# UNITED STATES PATENT AND TRADEMARK OFFICE

APPLICATION NO.	FILING DATE	FIRST NAMED INVENTOR	ATTORNEY DOCKET NO.	CONFIRMATION NO.
09/983,047	10/15/2001	Gregory H. Ames	78381	8178

# Office Action Summary

Figure 3a - U.S. Patent 6,218,661 to Schroeder et al., filed 10.16.98

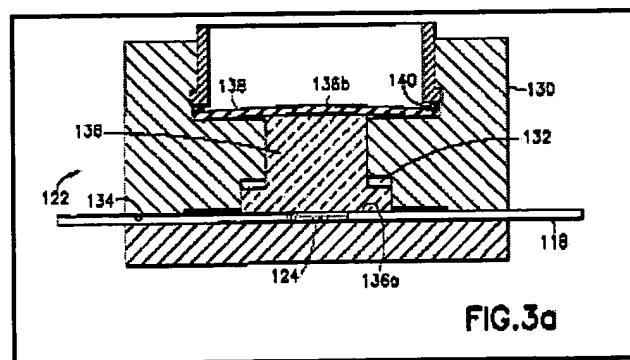
7. As per claim 1, 11 and 13, Schroeder et al. disclose an apparatus comprising at least one optical fiber (118) (see also Fig. 4 – not shown above – 234, 235) supported in a structure (130);

a movable mass (136) supported within the structure (130) and means (Fig. 1, not shown above; i.e. 12, 14, 16, 18, 20, 22, 24, 26) for detecting changes in tension in the at least one optical fiber due to movement of the movable mass (132) – (see abstract, Figs. 1-3).

8. As per claim 2, Schroeder et al. disclose an apparatus wherein the detecting means comprise at least one fiber optic Bragg grating (Fig. 3, 124) written into a core of each of said optical fibers.

10. As per claims 8 and 9, Schroeder et al. disclose an apparatus wherein the structure comprises a cage (Fig. 3 above) and wherein a gap is provided between each side of the mass and cage; the gap being sufficiently small to limit motion of the mass in shock or high acceleration and to limit the maximum tension seen by each of the optical fibers.
